N6705A-01A

S E R V I C E N O T E

N6705A DC Power Analyzer

Intermittent power on resets and power on lock ups.

Figure 1. Demonstration of the correct placement of the clamps

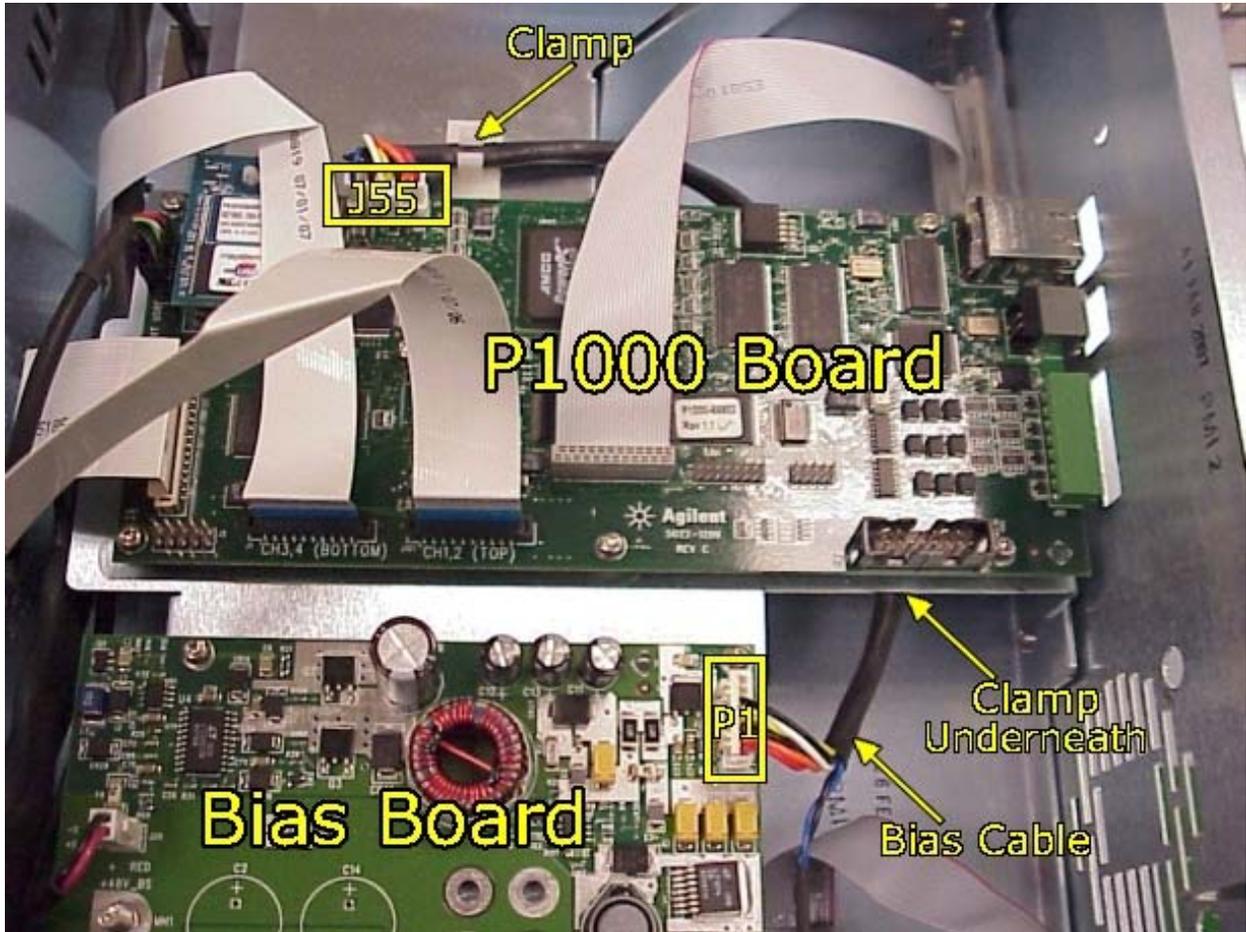
The N6705A unit is experiencing intermittent power on resets and power on lock ups. Symptoms include a white display and an unresponsive front panel with all the LEDs on. The symptoms described above will occur when there is poor or high contact resistance between the bias cable (P/N 5185-8813) and the connector J55 on the P1000 board (P/N 5022-1209) and the connector P1 on the bias board (P/N 5022-1208). The contact resistance of the bias cable and the connectors are affected due to vibration.

To eliminate the problem caused by vibration the bias cable will be secured to the chassis as shown in the following figures.

The two self-adhesive clamps are located:

1. Underneath the P1000 board on the bulk shroud. **Refer to Figure 2 for a detailed view.**
2. Next to connector J55 on the P1000 board. **Refer to Figure 3 for a detailed view.**
